**PCN#20140917000
TNR Device orientation change for LMP92018SQ Devices
Information Only**

PCN Number:	20140917000				PCN Date:	09/18/2014
Title:	TNR Device orientation change for LMP92018SQ Devices					
Customer Contact:	PCN Manager	Phone:	+1(214) 480-6037		Dept:	Quality Services
Change Type:						
<input type="checkbox"/> Assembly Site	<input type="checkbox"/>	Assembly Process		<input type="checkbox"/>	Assembly Materials	
<input type="checkbox"/> Design	<input checked="" type="checkbox"/>	Datasheet		<input type="checkbox"/>	Mechanical Specification	
<input type="checkbox"/> Test Site	<input checked="" type="checkbox"/>	Packing/Shipping/Labeling		<input type="checkbox"/>	Test Process	
<input type="checkbox"/> Wafer Bump Site	<input type="checkbox"/>	Wafer Bump Material		<input type="checkbox"/>	Wafer Bump Process	
<input type="checkbox"/> Wafer Fab Site	<input type="checkbox"/>	Wafer Fab Materials		<input type="checkbox"/>	Wafer Fab Process	
	<input type="checkbox"/>	Part number change

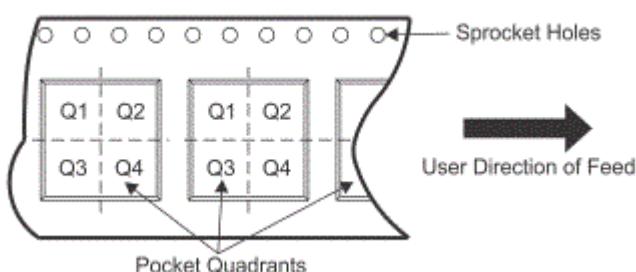
The LMP92018SQ device orientation in TNR will be changed so that it will be will be consistent with JEDEC and EAI481-D standards. The device orientation will be changed from Quadrant 1 to Quadrant 2:

Reason for Change:
To be consistent with JEDEC and EAI481-D standards.
Anticipated impact on Fit, Form, Function, Quality or Reliability (positive / negative):
None
Changes to product identification resulting from this PCN:
None
Product Affected:
LMP92018SQ/NOPB LMP92018SQE/NOPB LMP92018SQX/NOPB
